**Addendum No. 2  
January 19, 2024**

Project: **Lennox High School Addition**  
Lennox, South Dakota  
Architecture Incorporated Project No.: 2982

Architect: Architecture Incorporated

SCALE: 1/8" = 1'-0"

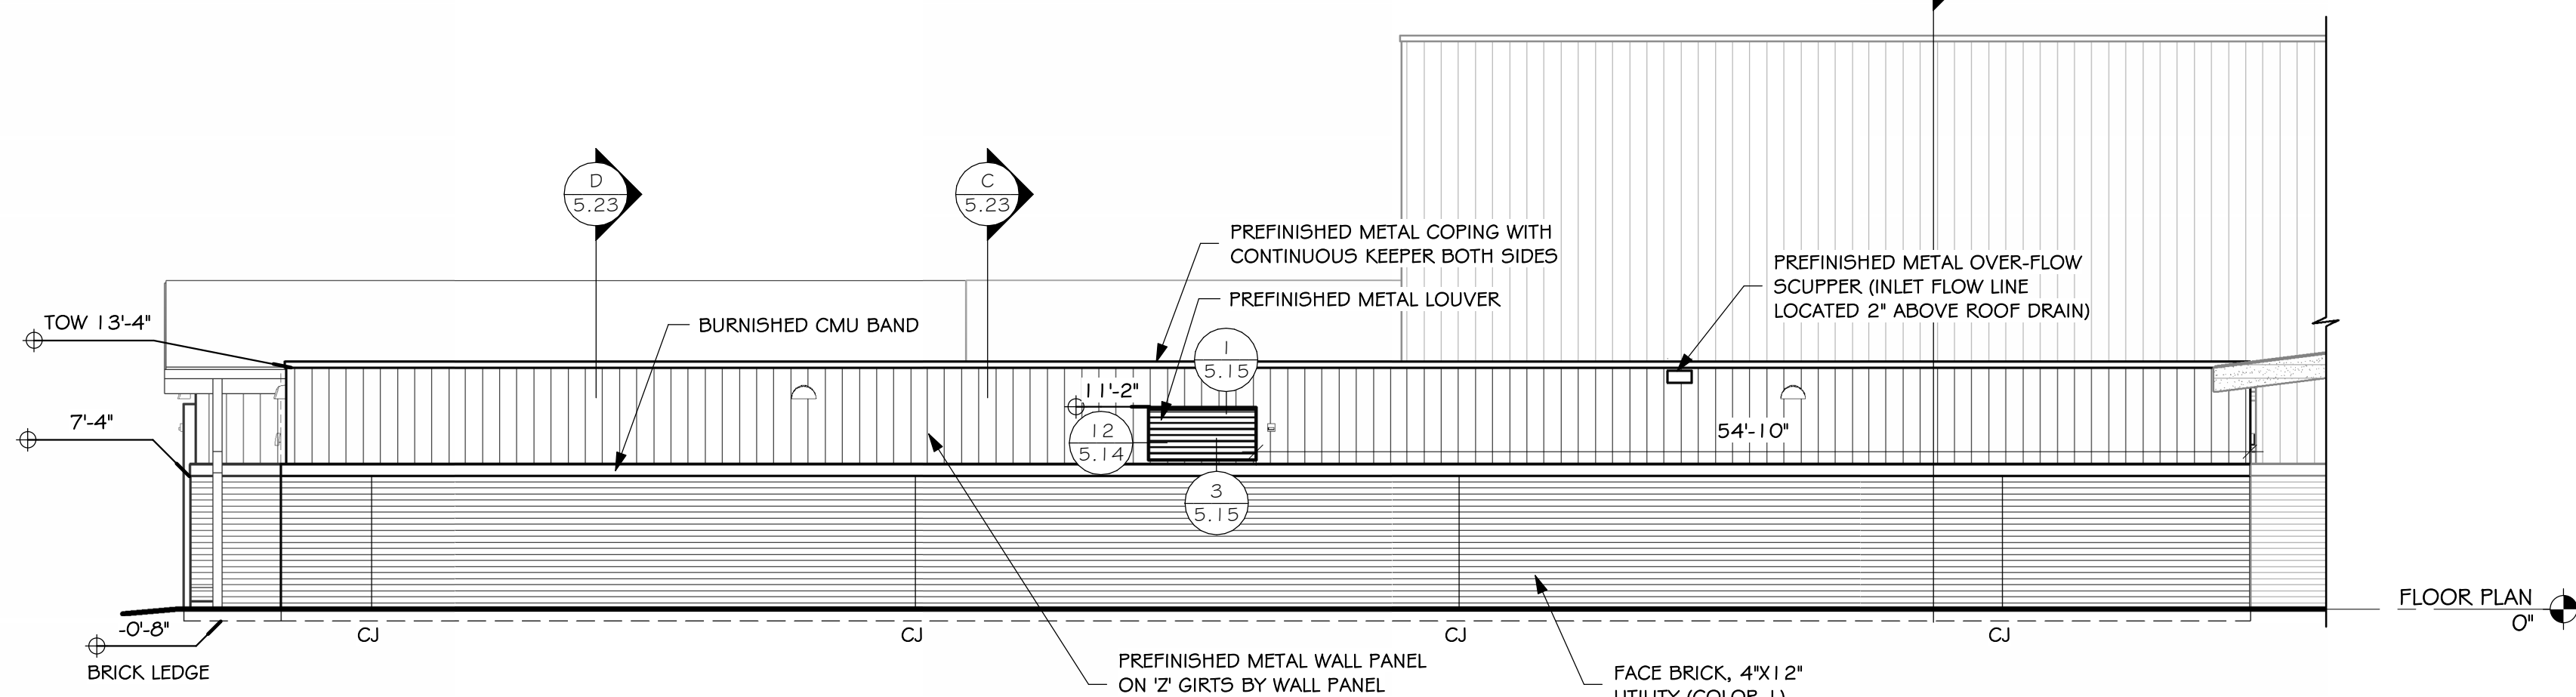
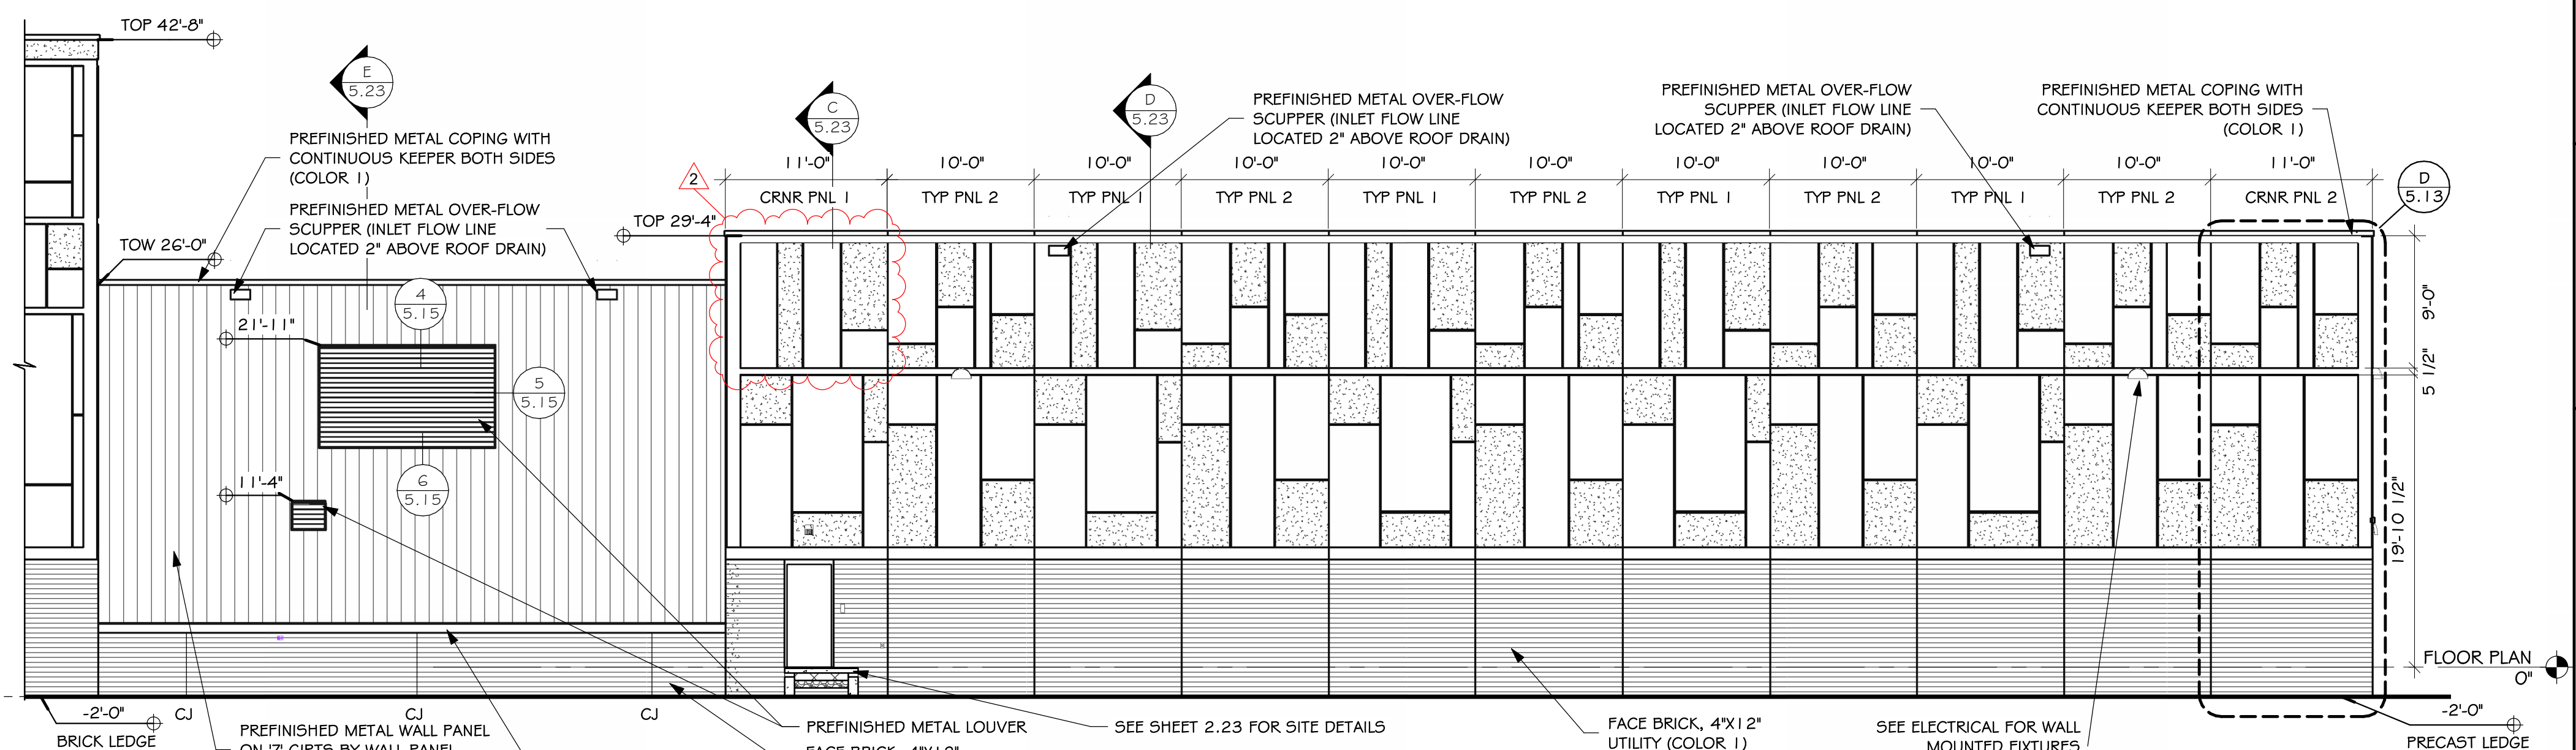
27) SHEET 5.10 – EXTERIOR ELEVATIONS

- a) Reference *revised* drawing Sheet 5.10, dated 1-18-24, attached to the end of this addendum for the following:
  - i. The exterior lettering shown above the new east entrance has been changed to read **“ACTIVITIES ENTRANCE”** in lieu of ACTIVITIES ENTRY.
    - 1. This exterior lettering shall be furnished and installed by the Contractor under his Base Bid.
    - 2. Reference Section 101419 “*Dimensional Letter Signage*”, dated 1-16-24, attached to the end of this addendum for product specification; 5 pages total.
  - ii. Corrections have been made with regard to the precast wall panel finish; reference exterior elevations A, B & C/5.10.

5.13

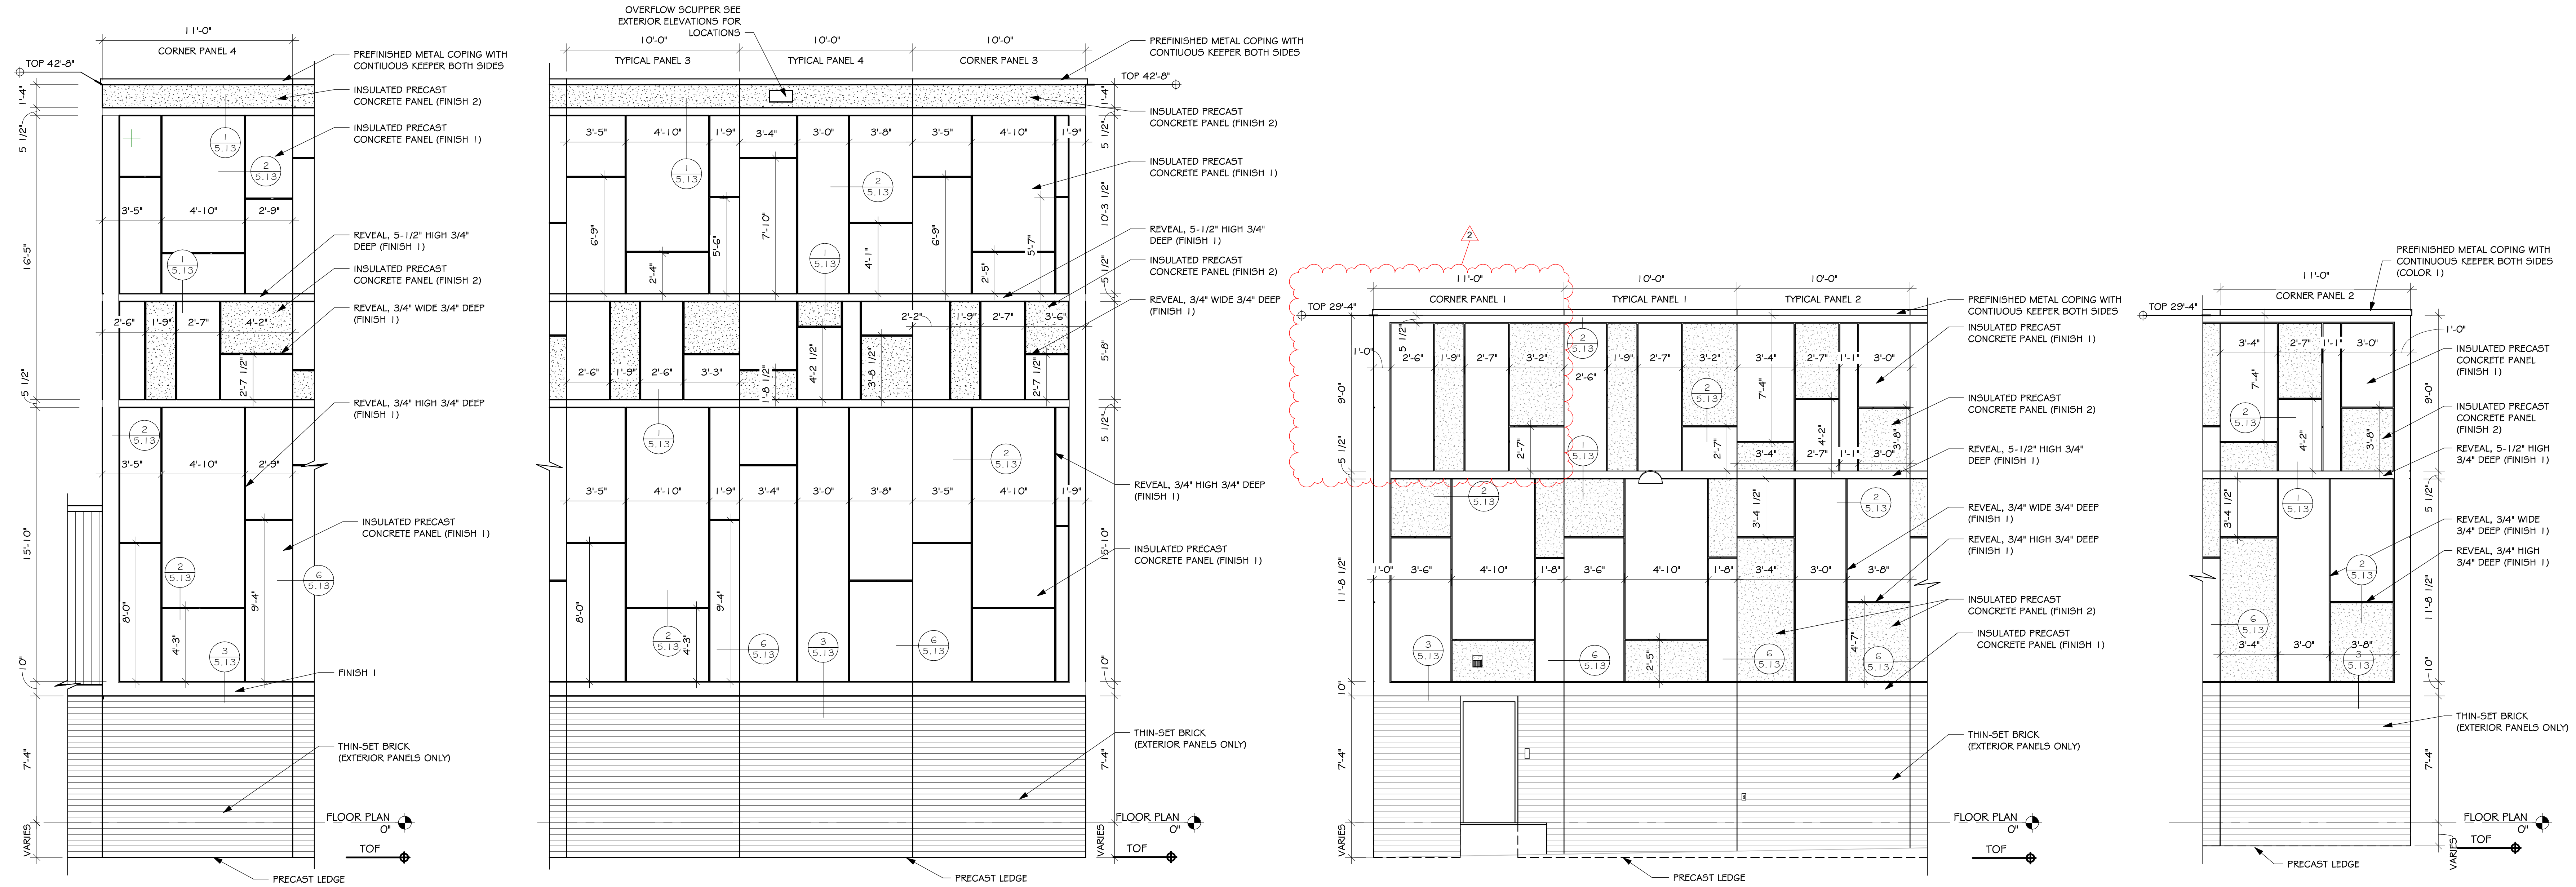
29) SHEET 5.13 – EXTERIOR ELEVATIONS

- a) Reference *revised* drawing Sheet 5.13, dated 1-18-24, attached to the end of this addendum for the following:
  - i. Corrections have been made with regard to the precast wall panel finish; reference exterior elevation C/5.13.
